Morecambe Offshore Windfarm: Generation Assets

Marine Mammal Technical Note 1 (EIA)

Document Reference: 9.25

Rev 02

Figure 2.2 Overall sampled underwater noise levels at Burbo Bank Extension site, March-April 2016

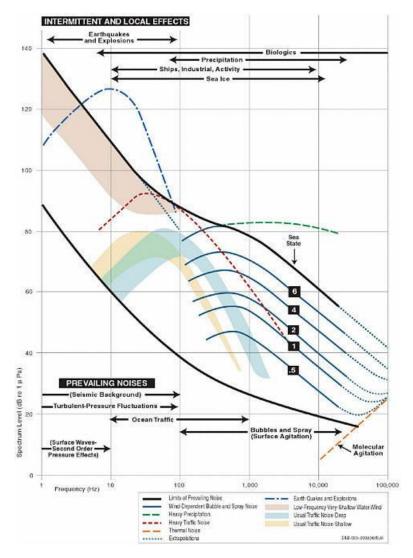
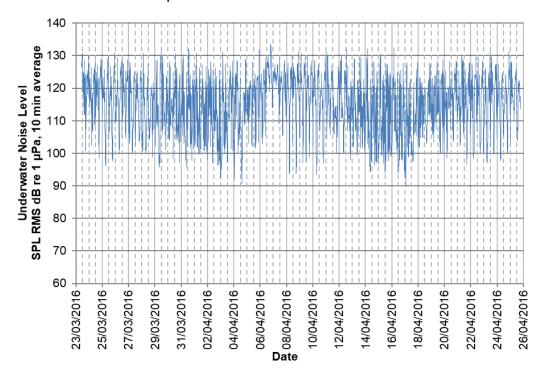
- 4. The following information is provided in response to NE's comment (NE Ref D16, RR-061-180):
 - "The baseline noise levels have not been presented, despite the NPS requirement".
- 5. The Applicant notes the National Policy Statement (NPS) EN-3 requirements (paragraph 2.8.131) (Department for Energy Security & Net Zero, 2023) state 'where necessary'. The Applicant considers that baseline noise levels do not contribute to the underwater noise assessment, which relies entirely on absolute noise thresholds as criteria. The Applicant has, however, prepared additional information (Section 2.1.1) regarding baseline noise levels to supplement Appendix 11.1 Underwater Noise Assessment (APP-065) and provide justification of the assessments with the Development Consent Order (DCO) Application.

15. In response to NE's comment on baseline noise levels (NE Ref D16, RR-061-180), the Applicant has undertaken a review of available evidence and data sources, including data collected for historic OWF in the Irish Sea, to meet the requirement of NPS EN-3 paragraph 2.8.131. The Applicant considers that the information presented is sufficient to demonstrate that the level of background noise is below the threshold at which it would influence the assessments, and therefore that the information in Appendix 11.1 Underwater Noise Assessment (APP-065) is unchanged.
